Appendix F
Hacienda at Fairview Valley Specific Plan Traffic
Analysis Adequacy Review and Peer Review

Subject: Hacienda at Fairview Valley Specific Plan Traffic Analysis Adequacy Review

Subject: Peer Review of *Hacienda at Fairview Valley Specific Plan Traffic Analysis Adequacy Review*

Subject: Response to Comments by Bob Davis from RBF Consulting, on July 22, 2013, regarding the Hacienda at Fairview Valley Specific Plan Traffic Analysis Adequacy Review, prepared on June 12, 2013

EXISTING NUMBER OF THROUGH LANES AND INTERSECTION CONTROLS

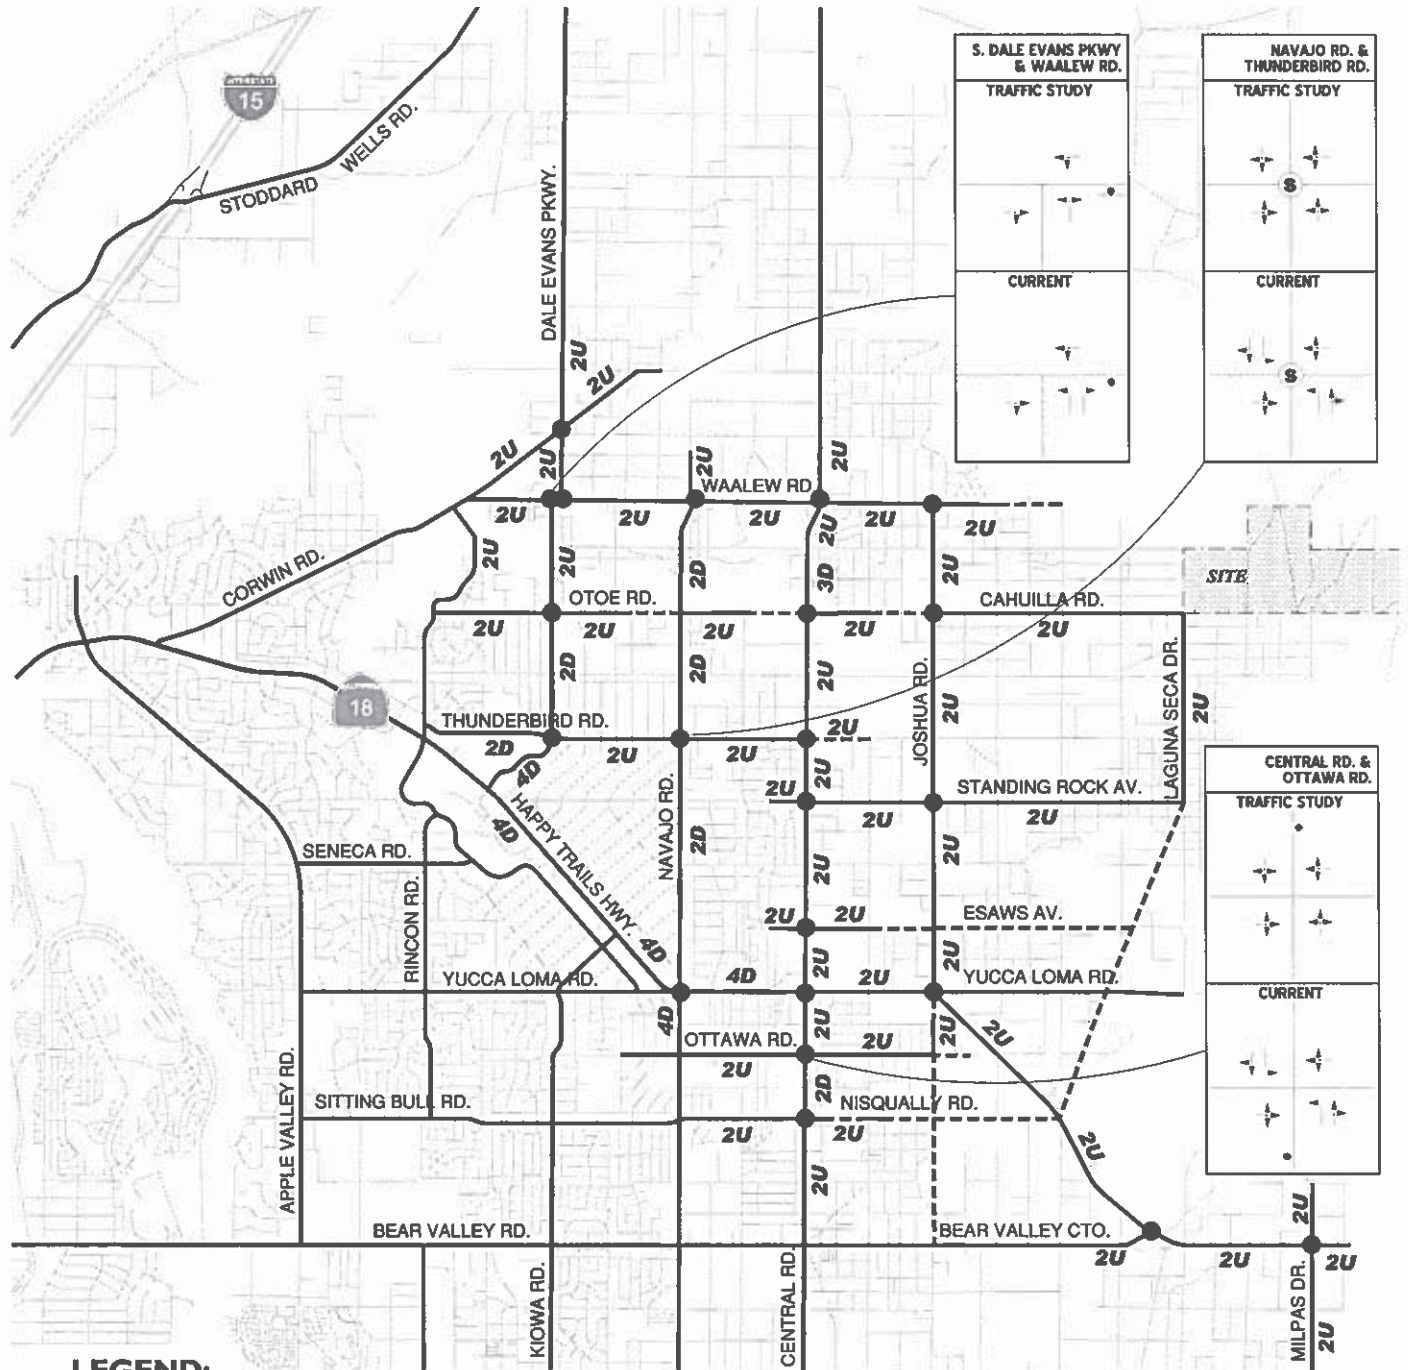
3. We concur that it was necessary to update the inventory of the existing roadway system characteristics and to identify recent roadway and intersection improvements. While the improvements clearly provide additional roadway capacity, we do not agree that the conclusion made by Urban Crossroads that the impacts identified in the published environmental document are more conservative since the analysis assumes that improvements are not in place yet. This would only be valid if the existing traffic volumes have not increased in a manner that would offset the increase in capacity. If it can be demonstrated that traffic has not increased significantly at these locations, then the finding could be made that the original analysis was more conservative. I suggest that Urban Crossroads move their conclusion discussion to the end of the section after the discussion of changes in existing traffic volumes.

We concur that it was necessary to update the inventory of the existing roadway system characteristics and to identify recent roadway and intersection improvements. While the improvements clearly provide additional roadway capacity, we do not agree that the conclusion made by Urban Crossroads that the impacts identified in the published environmental document are more conservative since the analysis assumes that improvements are not in place yet. This would only be valid if the existing traffic volumes have not increased in a manner that would offset the increase in capacity. If it can be demonstrated that traffic has not increased significantly at these locations, then the finding could be made that the original

analysis was more conservative. I suggest that Urban Crossroads move their conclusion discussion to the end of the section after the discussion of changes in existing traffic volumes.

An EIR's evaluation of environmental impacts should normally measure the changes a project will make in physical conditions in the area affected by the project as they exist when the notice of preparation is published. (State CEQA Guidelines, § 15126.2(a); *Communities for a Better Env't v. South Coast Air Quality Mgmt. Dist.* (2010) 48 Cal.4th 310, 320.) Although recent case law supports the use of a future baseline for the assessment of environmental impacts, such a baseline is appropriate only if some unusual aspect of the project at issue or the surrounding circumstances justifies the use of the future baseline. No such unusual circumstances or conditions are present here. Therefore, reference to the conditions at the time the NOP was published, here, is the baseline against which the environmental impacts of the Project were assessed. With the addition of the improvements in the interim, the EIR therefore offers a conservative analysis of the Project's traffic impacts as it does not account for these improvements, but rather assumes the maximum traffic impacts resulting from the Project. Furthermore, although updated traffic data was not required, updated traffic data was provided in 2011 and included in a memorandum to the County. The memorandum confirms the adequacy of the EIR's analysis in light of the current traffic data and improvements.
